NOVI CONCRETE PLANT JSP22-08

Public hearing at the request of Crown Enterprises, LLC, for Preliminary Site Plan, Wetland Permit, Woodland Permit, and Storm Water Management Plan approval for a new 8,700 square foot concrete plant with two silos. The subject property is approximately 20 acres and is located at 46844 Twelve Mile Road in Section 9, north of Twelve Mile Road and west of West Park Drive. The southern portion of the site is zoned I-1, Light Industrial District and the northern portion is zoned I-2, General Industrial District.

PLANNING REVIEW

Planning Review NOVI CONCRETE PLANT

SHEET NUMBER: CS-100 ISSUE

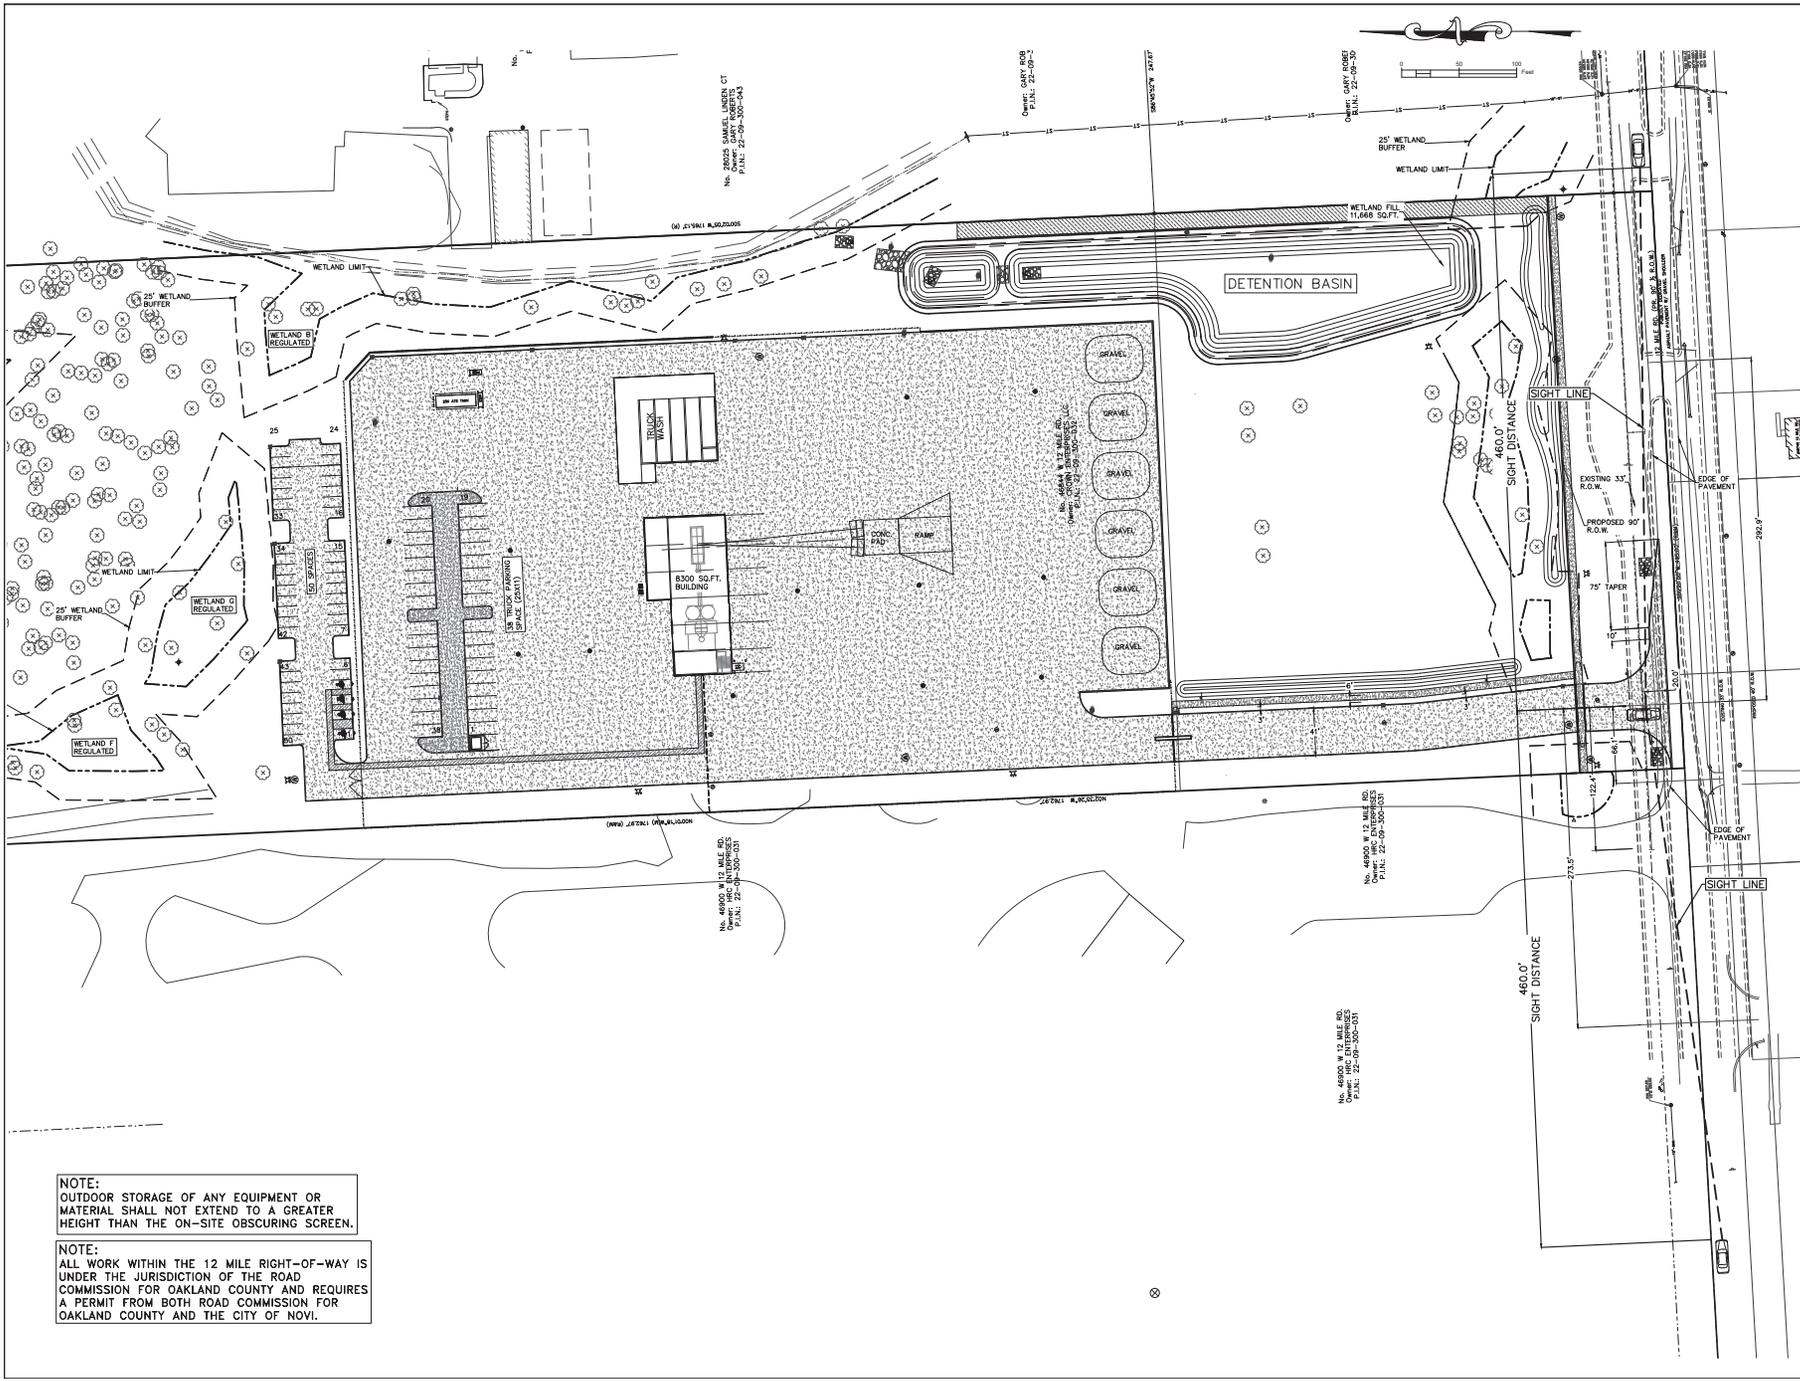
4. Dumpster Enclosure (Sec. 21-145 (c), Code of Ordinances): The proposed dumpster enclosure appears to comply with ordinance standards. However, the height of the dumpster has not been confirmed. **Please provide a standard note on the plans indicating that the height of the enclosure will be a minimum of 1 foot taller than the height of the dumpster.**

Response: This note has been added to the Dumpster Enclosure Elevation on Sheet A-302, with a reference note included on the Site Plan Sheet CS-100.
5. Woodland Use Permit: A Woodland Use Permit will be required for this project as 82 regulated woodland trees are proposed to be removed. **This permit will require 138 Woodland Replacement Credits and Planning Commission approval. Please indicate if any woodland trees are proposed to be replace on-site in a proposed conservation easement. Any outstanding credits will be required to be paid into the City Tree Fund at \$400 per credit.**

Response: The maintenance access is shown on Sheet CS-100.

Response: A path was provided and is shown on all the plans, see Sheet CS-100

SHEET NUMBER	ISSUE
CS-102

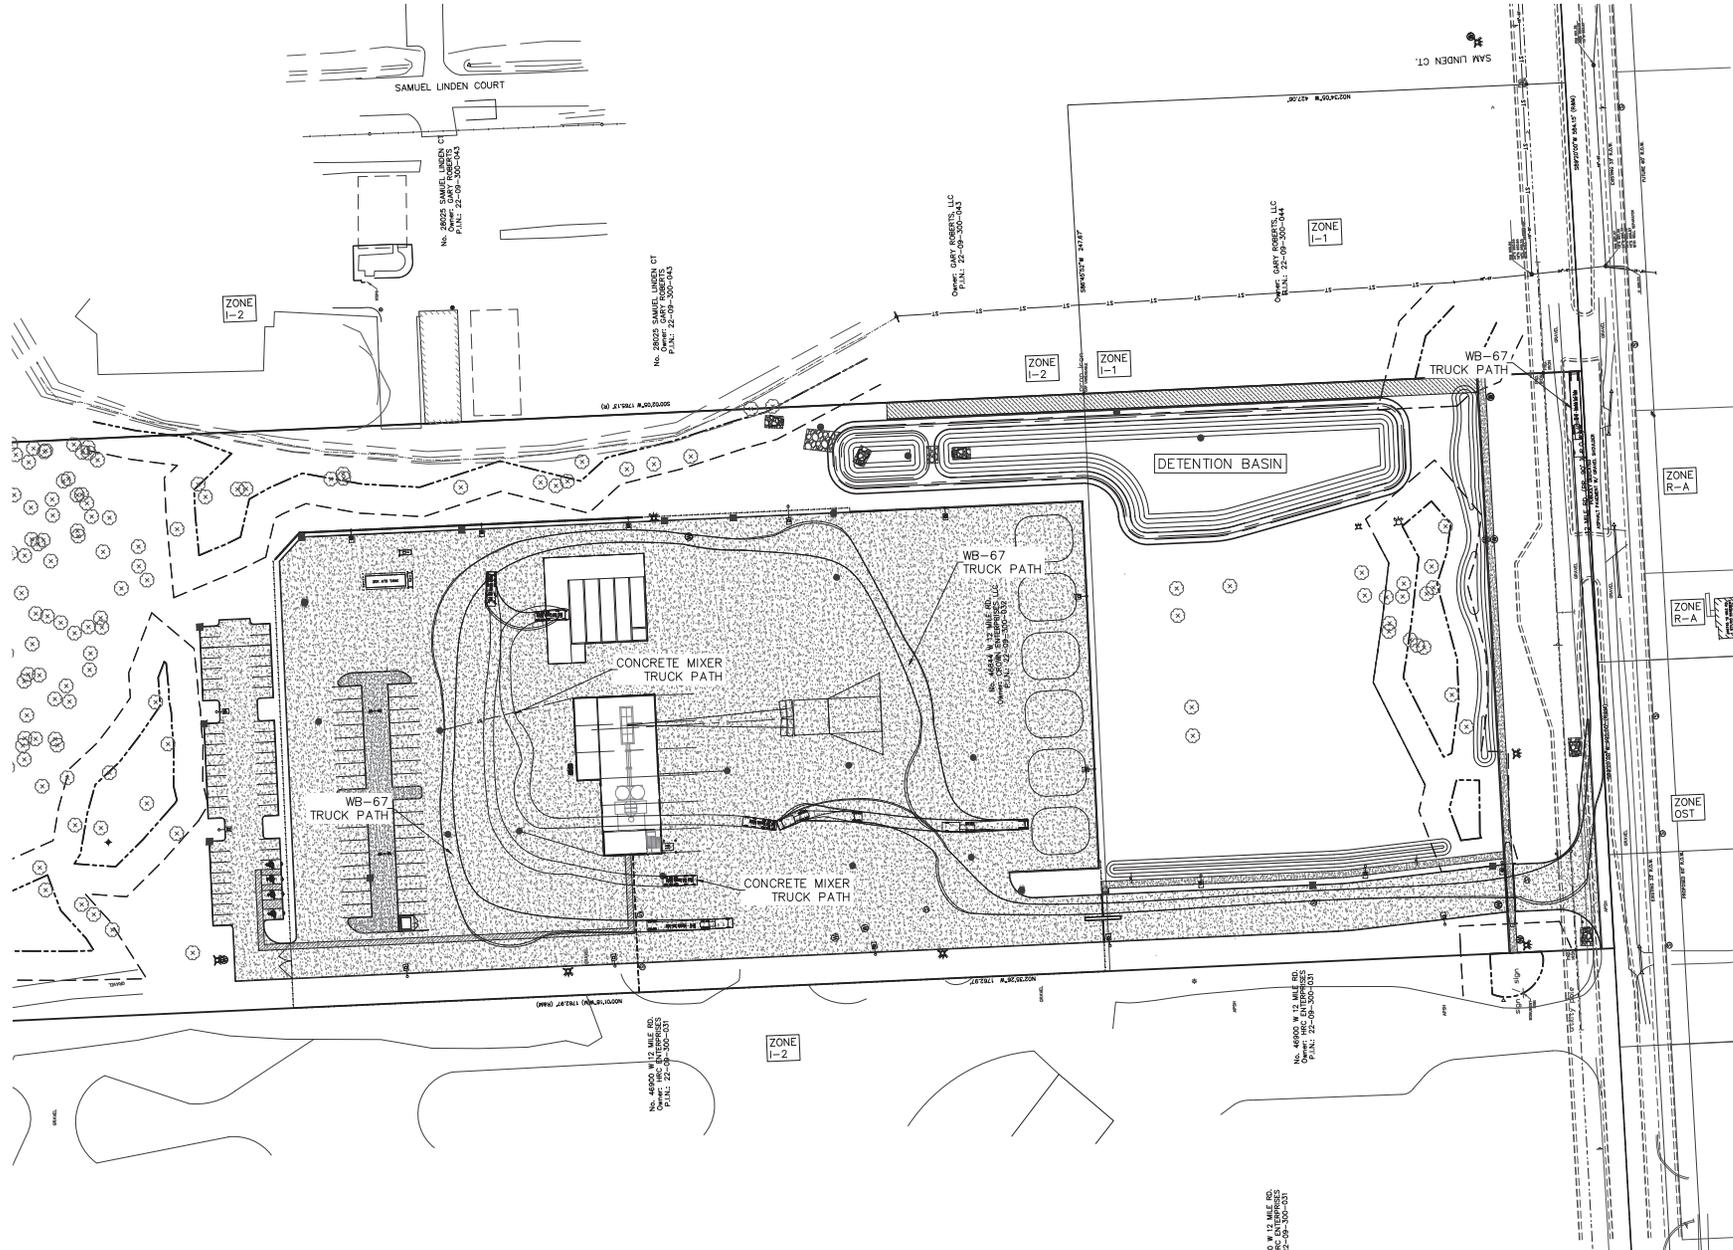
7. Same Side Driveway Spacing Waiver (Sec. 11-216.d.1.d): A same side driveway spacing waiver is required for the proposed access drive on Twelve Mile Road. The proposed driveway is 122.4 feet from the driveway to the west and 230 feet is required. The distance to the driveway to the east has not been indicated and 230 feet is required. **Please indicate the distance to the driveway to the east in the response letter and on the plans. AECOM and City Staff supports the waiver as the site could not be accessed from Twelve Mile Road without a waiver.**

Response: The proposed distance to the driveway to the east is provided on Sheet CS-102. A **Waiver** for the driveway spacing is requested.

SHEET NUMBER	ISSUE
CW-100

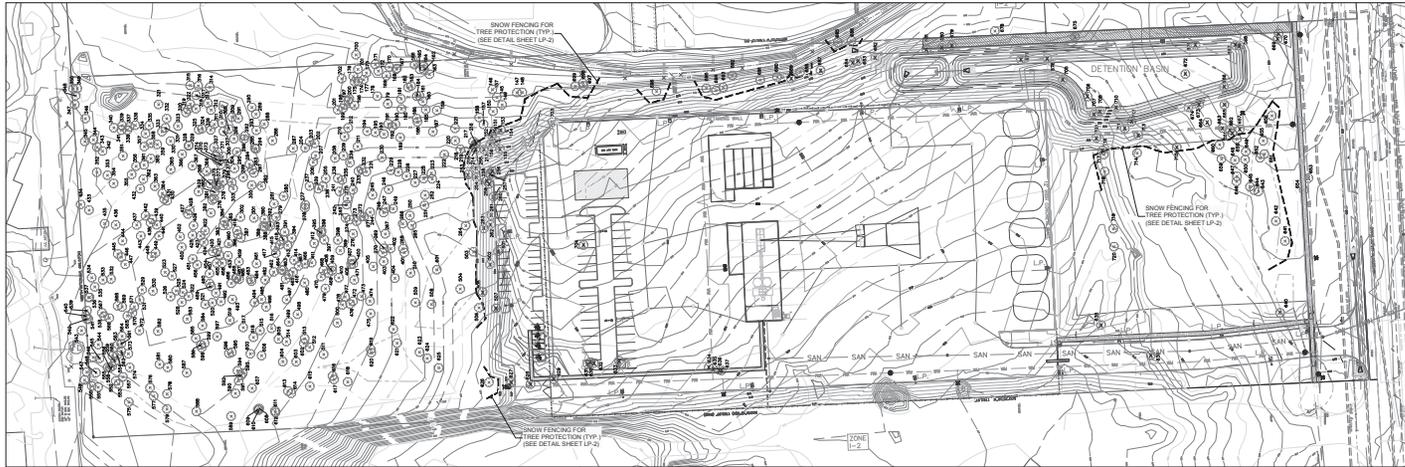
6. Wetland Use Permit: A Major Wetland Use Permit **is still required** for this project as 0.25 acres of regulated wetland is proposed to be filled. **Please revise the plan to reduce the wetland impact below 0.25 acres if you wish to seek a Minor Wetland Use Permit and clearly indicate this in the response letter. In addition, the site plan notes a future development area near the Twelve Mile Road frontage. If this site were to be developed and the remainder of Wetland A were to be filled, a Major Wetland Use Permit and on-site mitigation would be required at that time (only if the current plan is revised to reduce current wetland impacts below 0.25 acres). Please refer to the Wetland Review letter for additional information.**

The *Site Plan* (Sheet CS-101) indicates the presence of four wetland areas located in the northern, eastern and southern portions of the Site. The rPSP and details of the wetlands provided on the *Wetland Impact Plan* (Sheet CW-100) do not show the total wetland areas on Site, but do indicate total proposed impacts of 0.25-acre wetland impact and 0.47-acre of 25-foot Natural Features Setback (wetland buffer) impact, as summarized in Table 1, below.

Response: The revised Wetland Impact of 0.22 acres and approximately 295.70 cubic yards of fill is provided on Sheet CW-100. The project now meets Minor Wetland Use Permit criteria and falls below the City's 0.25-acre threshold for mandatory wetland mitigation. The reduced impacts were achieved by reducing the parking spaces by 4 and lowering the parking lot grading.

Response: The existing wetlands and wetland buffers, and the proposed wetland impacts are shown on Sheet CW-100.

TPP - 1: TREE PRESERVATION PLAN

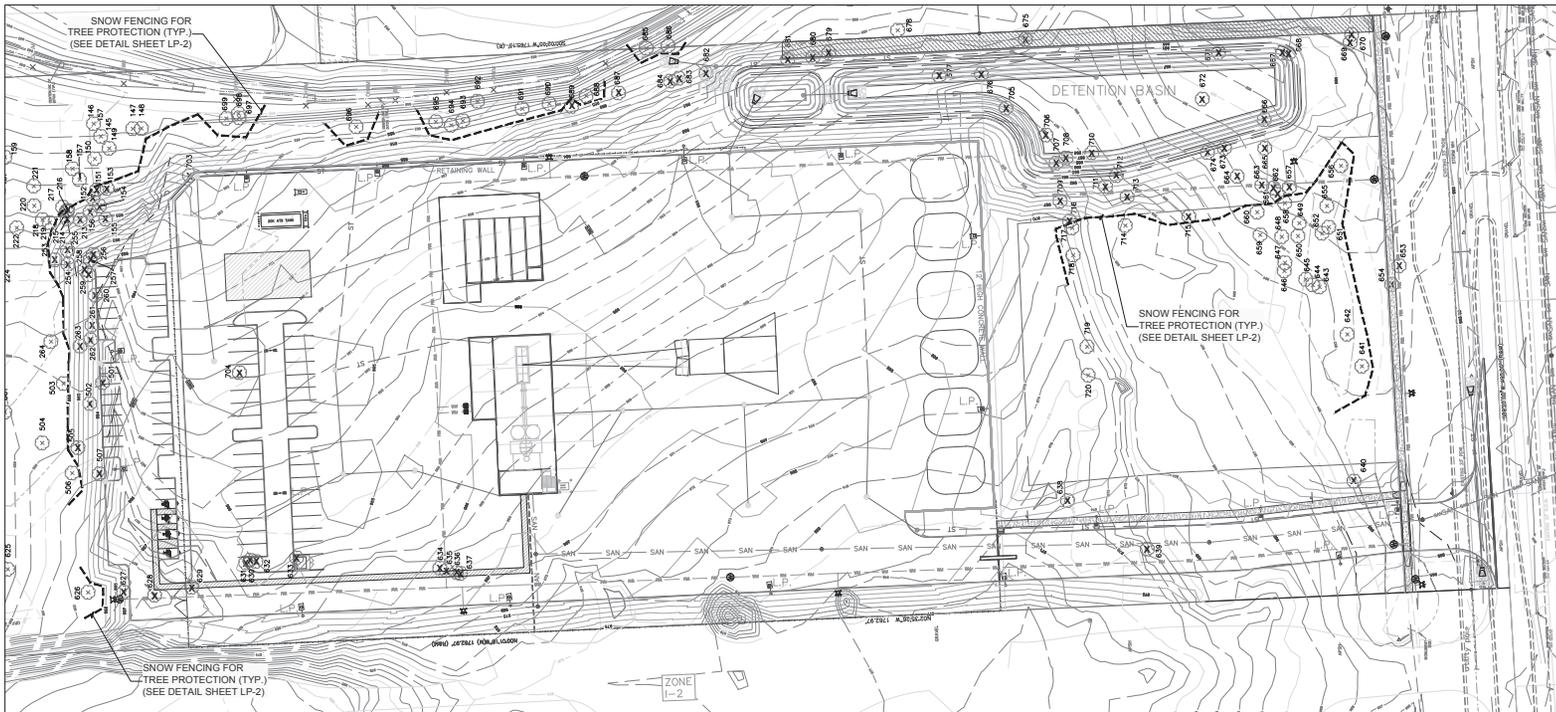
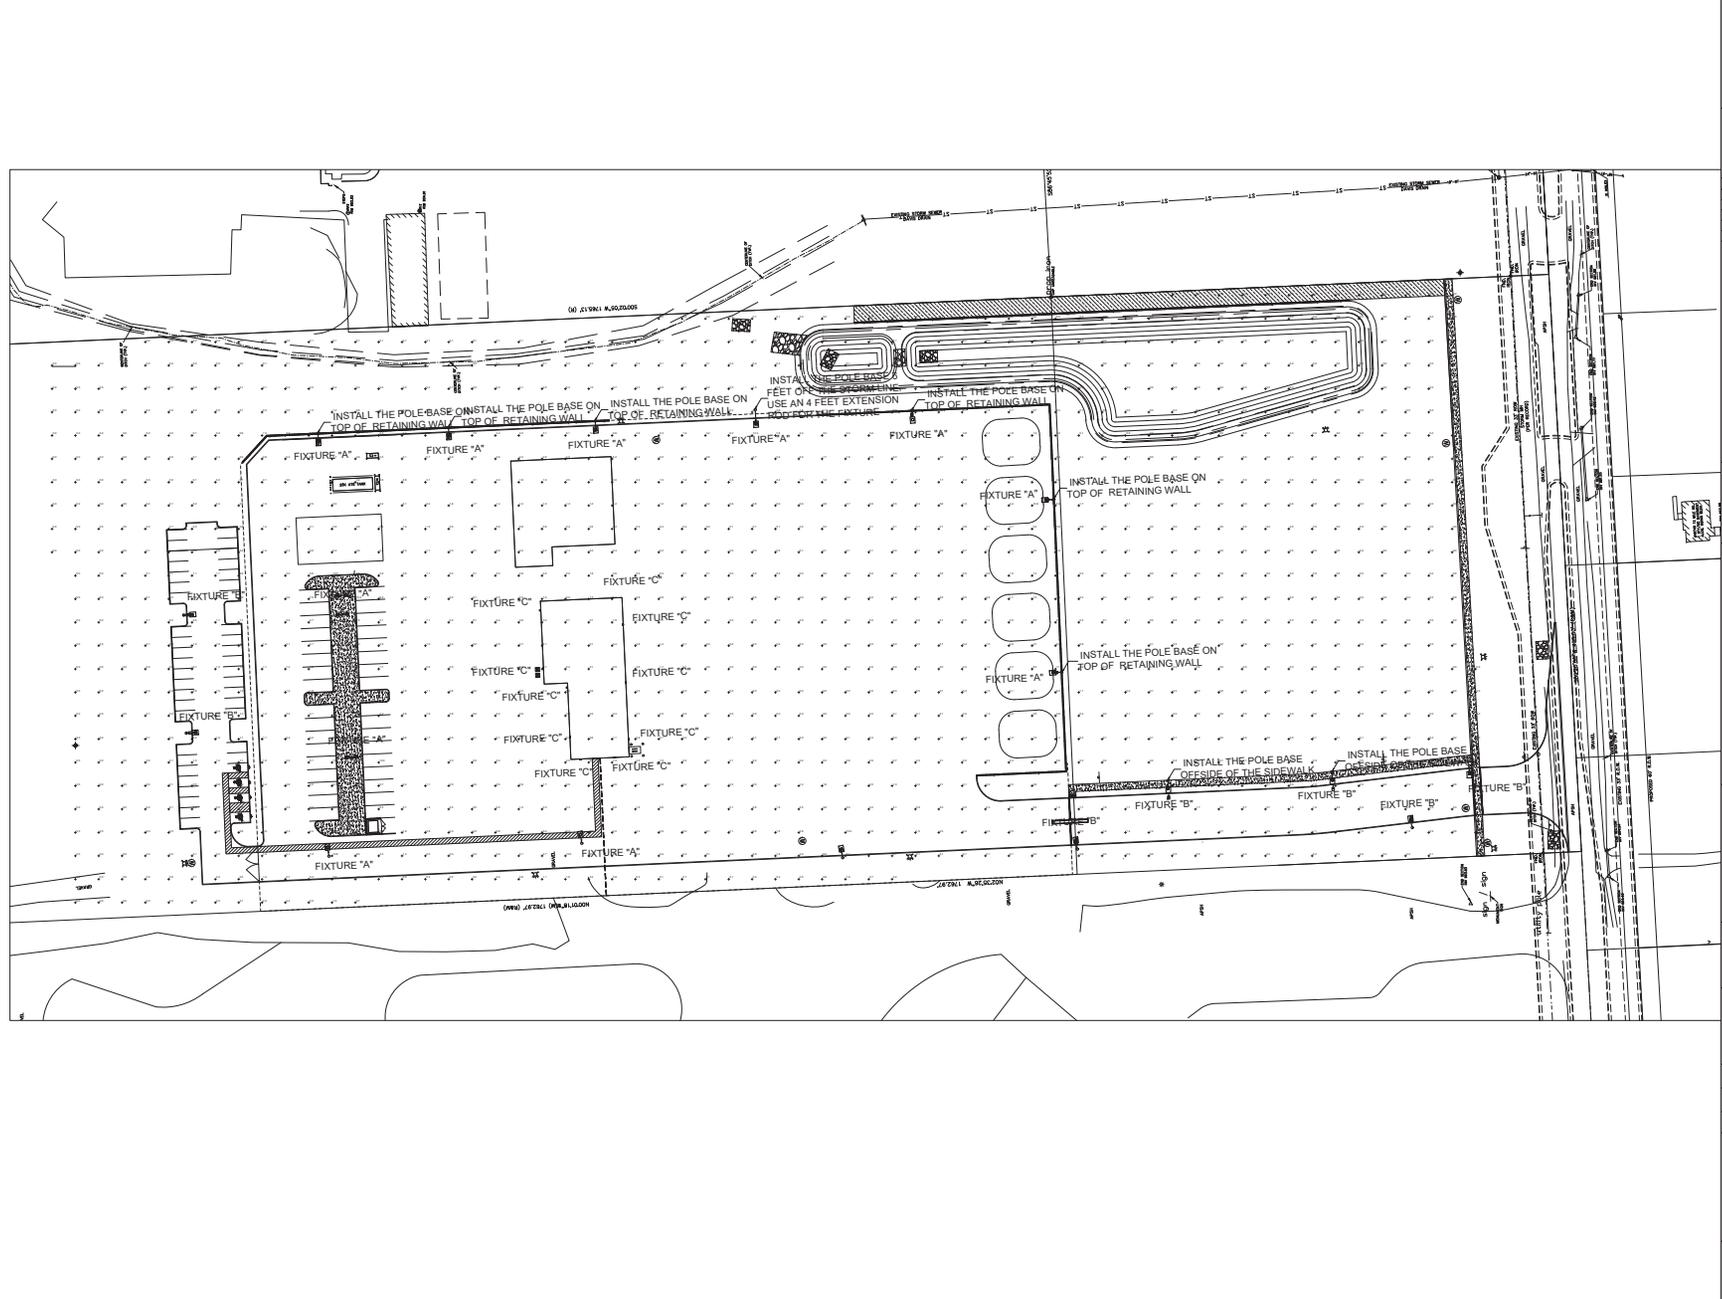
5. Woodland Use Permit: A Woodland Use Permit will be required for this project as 82 regulated woodland trees are proposed to be removed. **This permit will require 138 Woodland Replacement Credits and Planning Commission approval. Please indicate if any woodland trees are proposed to be replace on-site in a proposed conservation easement. Any outstanding credits will be required to be paid into the City Tree Fund at \$400 per credit.**

Response: The updated tree replacement summary is provided on Sheet TPP-1. Total replacement of (119) trees will be provided with (52) plantings plus (67) outstanding credits.

1. Provided
2. **Please plant as many replacement credits as possible on the site.**
Response: Fifty two (52) replacement trees are now specified on Sheet TPP-1. Sixty-seven (67) replacement credits are required.
3. **Woodland replacement trees may be used for the screening along the east and west sides of the site. They may also be used to meet the detention basin tree requirement.**
Response: Deciduous trees around the stormwater basin are categorized as replacement trees.
4. **Excess shrubs (those around the detention pond that exceed the 70% coverage requirement) may also be used toward the Woodland Replacements per the Reforestation Credit Table in Section 37-8.**
